Southern Joint Regional Planning Panel
Planning Panels Secretariat
GPO Box 39
SYDNEY NSW 2001

RA15/1000
Multistorey Carpark Worrigeer/Berry Streets Nowra

Shoalhaven City Council as applicant for RA15/1000 addresses the JRPP's reasons for deferral dated 22.11.2016 with the submission of revised documentation including a Landscape plan, Architectural plans and a supporting Arborists report. The recommendations provided by the JRPP are listed below and briefly addressed:

DIRECTOR OF ASSETS & WORKS:	DATE:
	03/09/18
- PLAN REFERENCE -	
1311_15

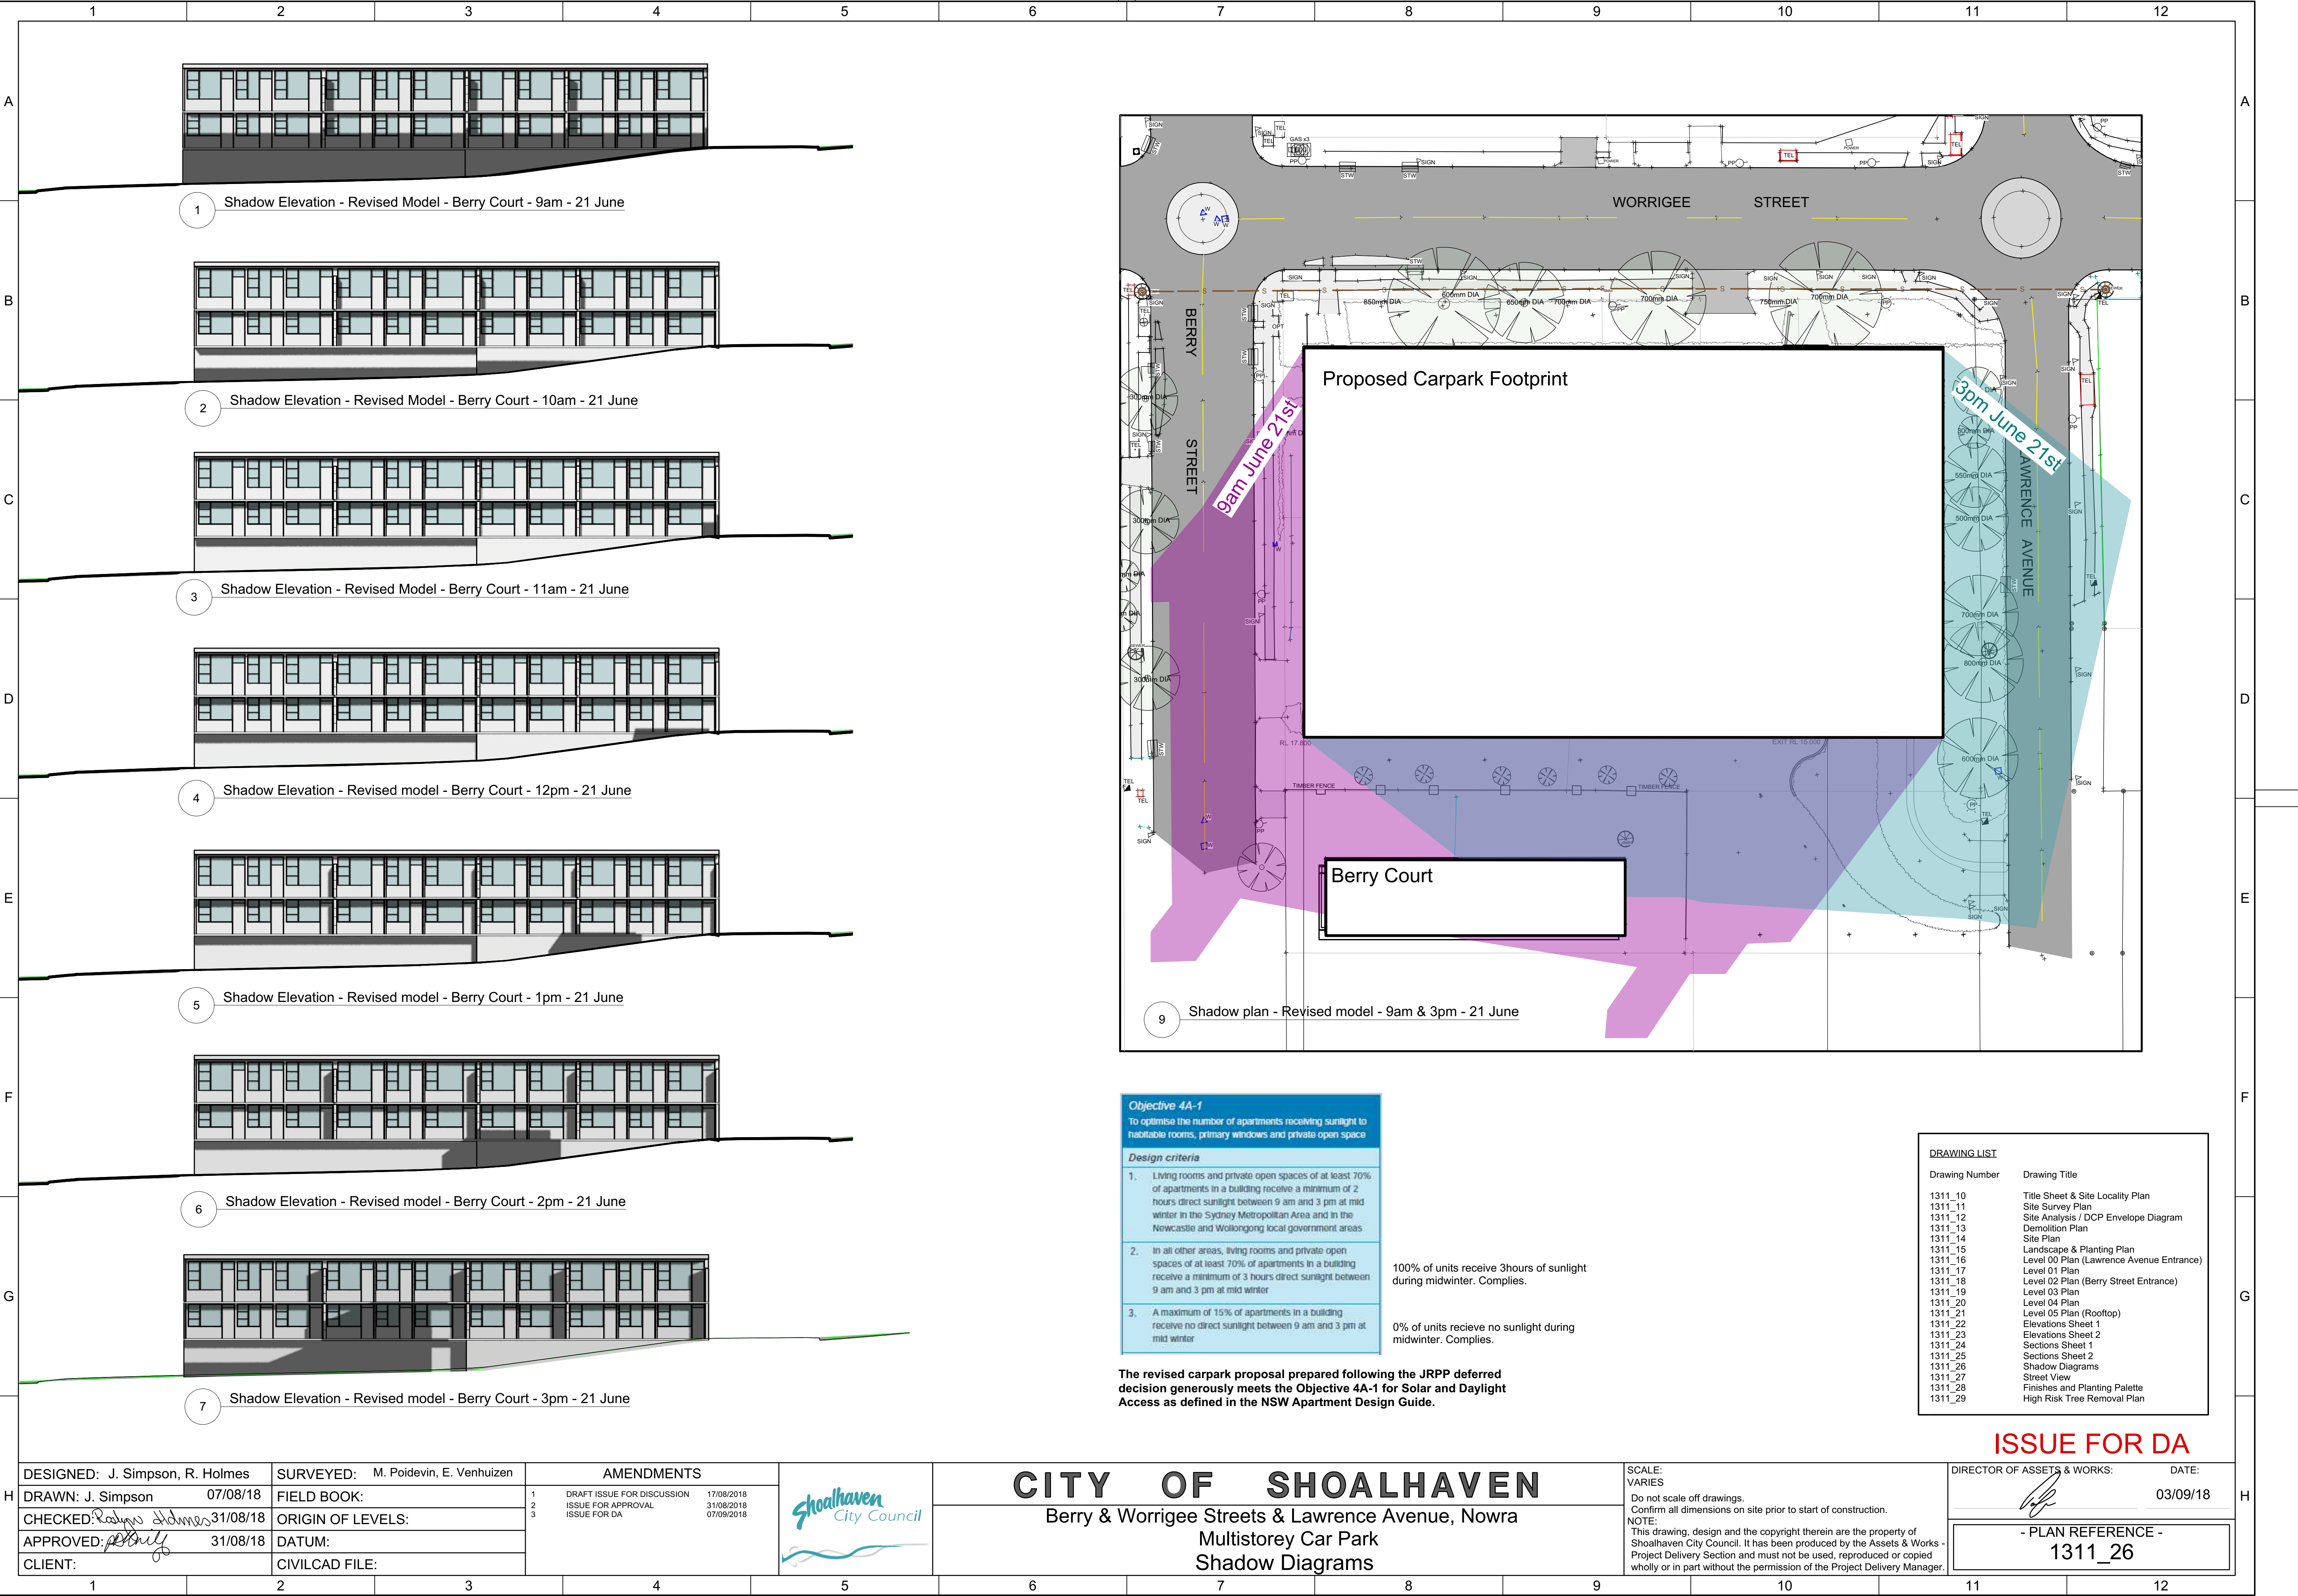
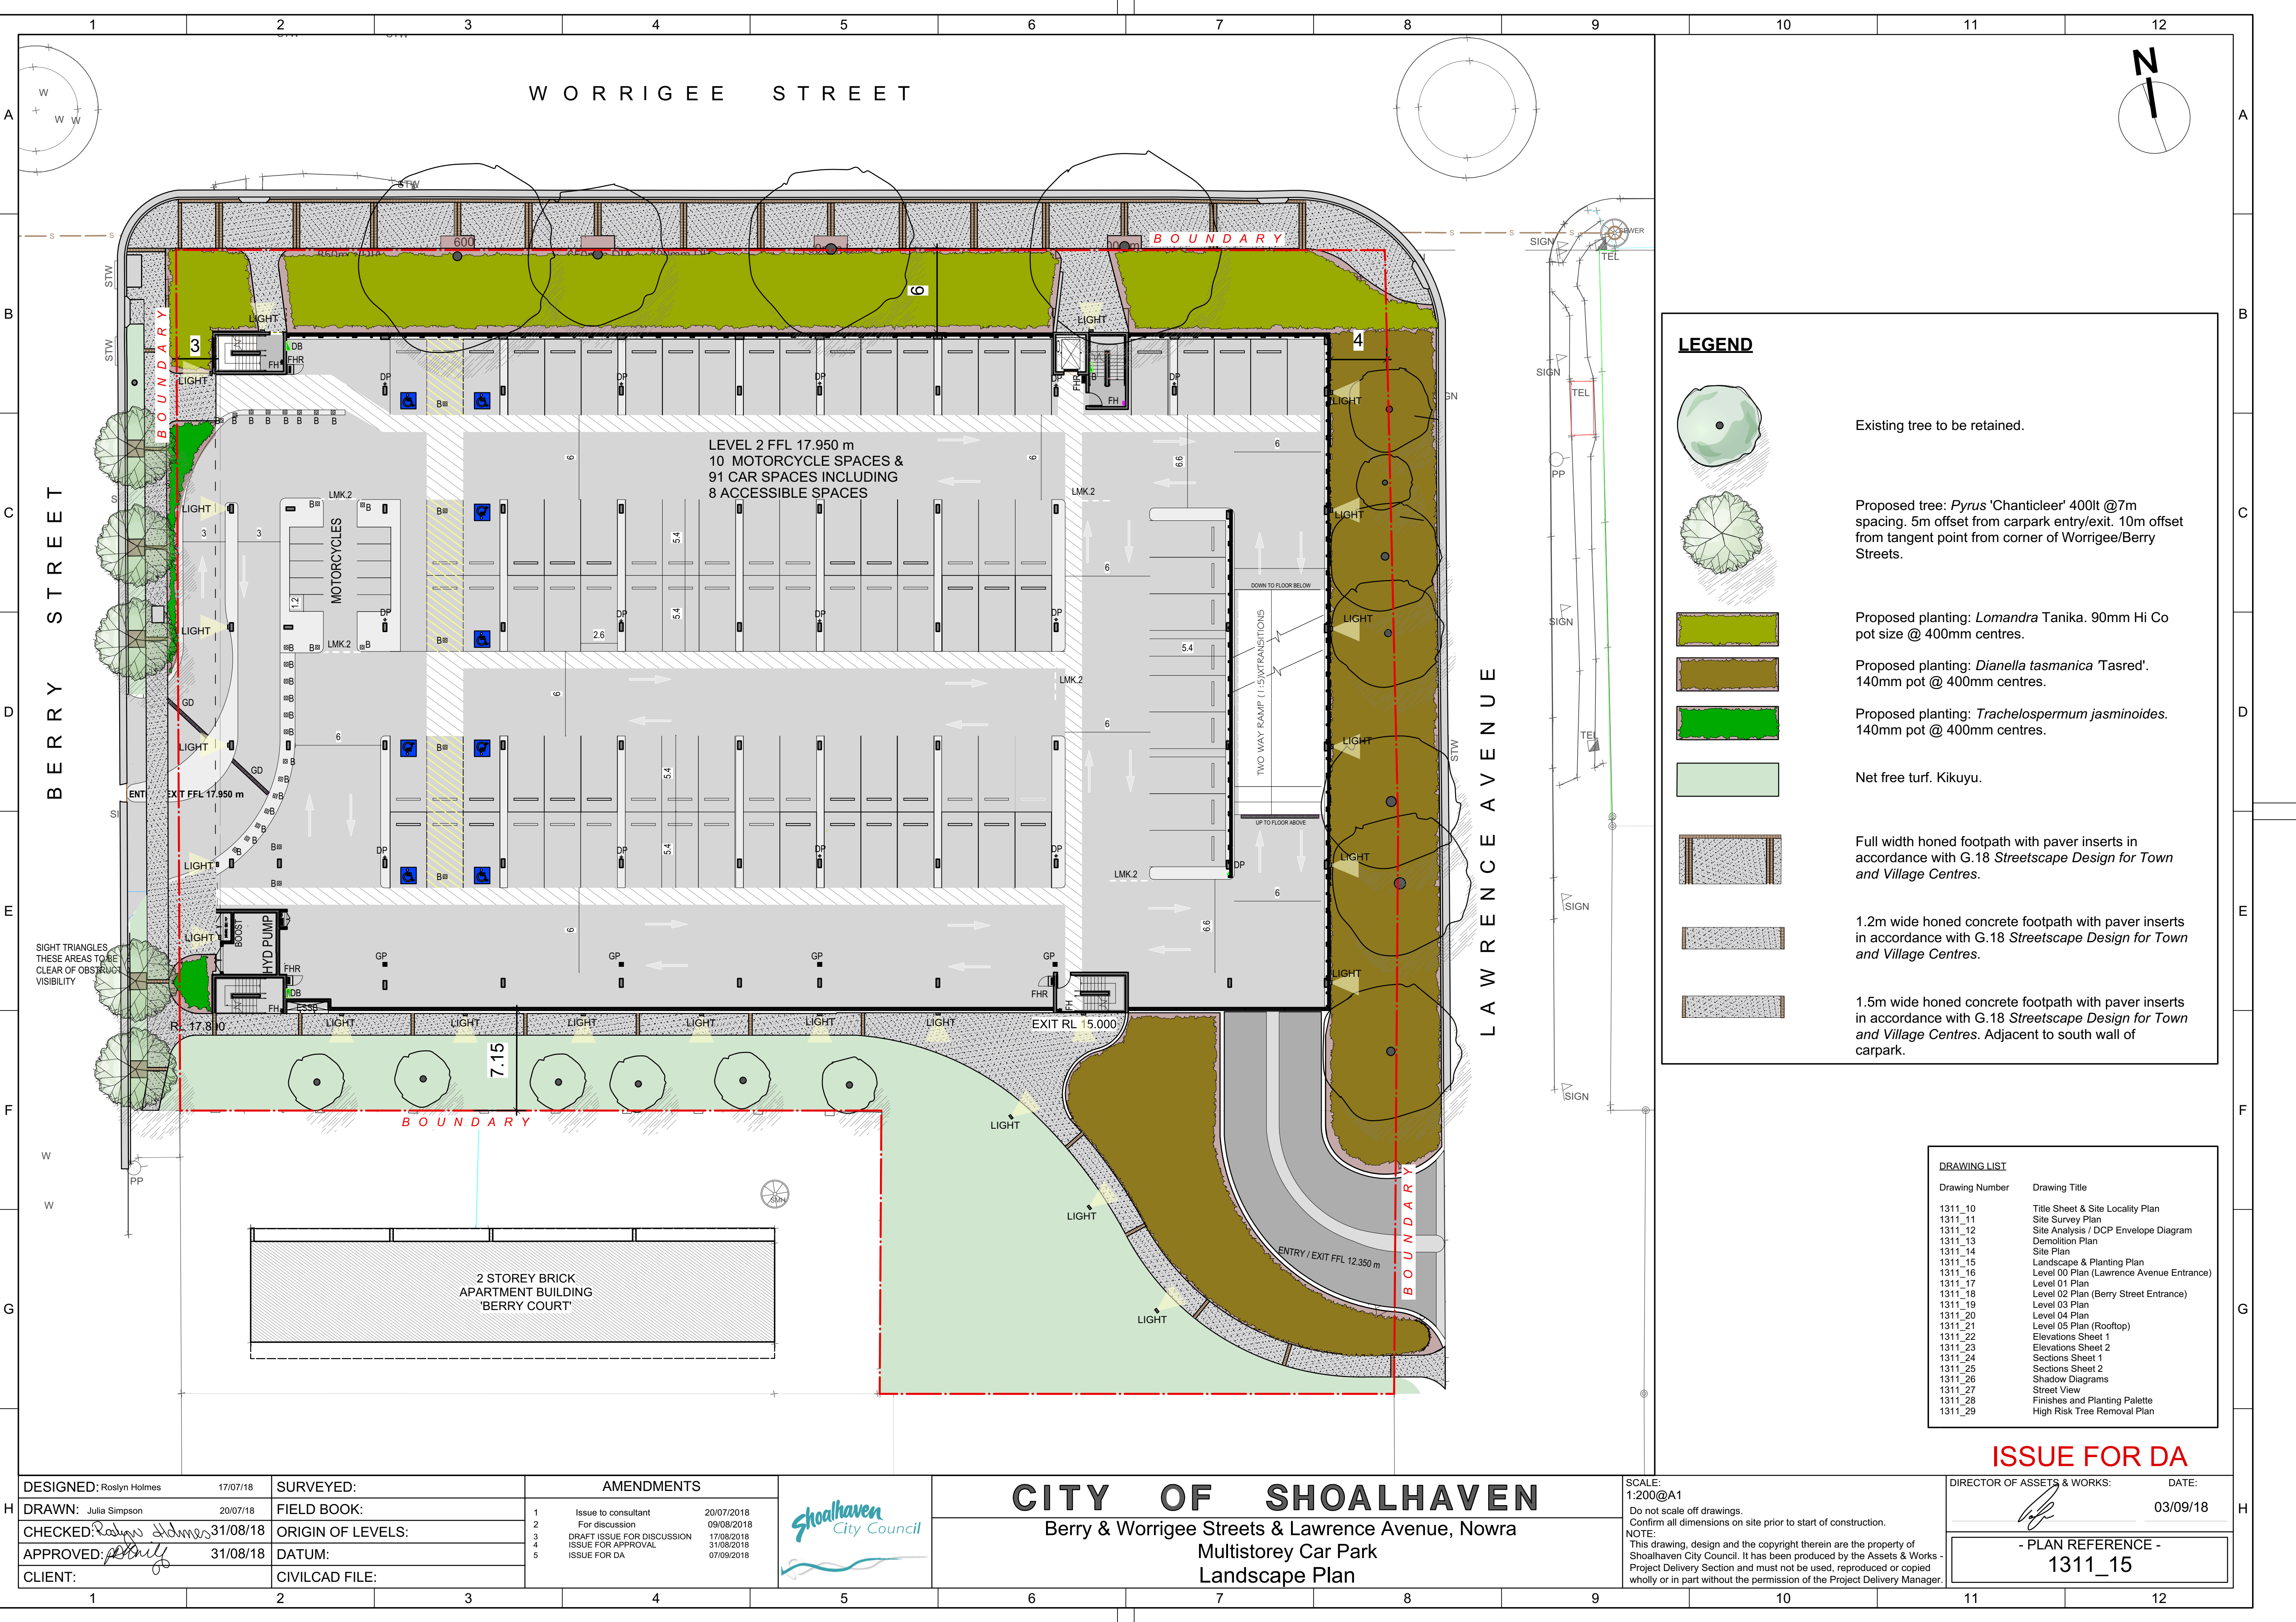
4. *Amended Landscape plan that provides details of the proposed vegetation along the southern setback between the site and Berry Court and is to make provision for suitable native vegetation.*

It is proposed that the six existing trees (*Eleaocarpus eumundii*) located on the southern boundary of the site are retained and protected. The species is an Australian native rainforest tree. The submitted Landscape plan 1311_15 provides details of landscape treatment to the whole of site.
